Project Address: 820 South Park Street, 905-911 Delaplaine Court, 910-930 Haywood Drive, and 825-831 South Brooks Street (13th Aldermanic District, Alder Eskrich)

Application Type: New Construction in UDD No. 7, Preliminary Plat, Rezoning, Demolition and Conditional Use

Prepared By: Heather Stouder, AICP, Planning Division
Report Includes Comments from other City Agencies, as noted

Summary of Revisions

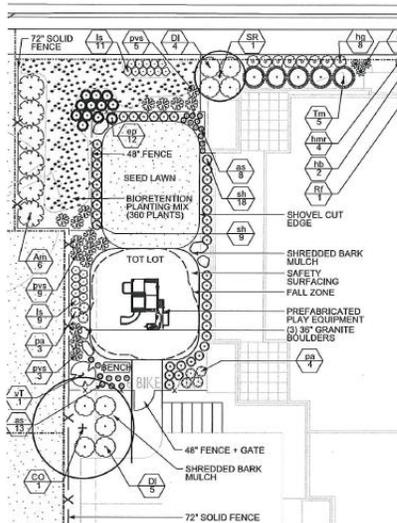
5. **Tot Lot Access** - Improved access to the open space with the tot lot by providing direct pedestrian access from Delaplaine Court, and by providing a safer and more contiguous sidewalk path to the southern entrance open space. This was accomplished by mirroring the surface parking area so that the parking stalls are on the east side, closest to the building, and moving/maneuvering traffic would be on the western edge of the site (see excerpt below). The adjustment in driveway location will result in the ability to save one 11" caliper street tree along Haywood Drive formerly planned for removal, but will necessitate removal of a smaller 6" caliper street tree formerly planned to be protected.

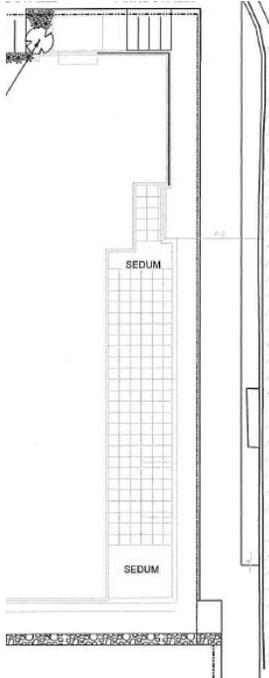
6. **Park Street Landscaping** - Additional 4-foot deep landscaped buffer areas along S Park Street, where there had been no landscaping in previous plans (see excerpt below)
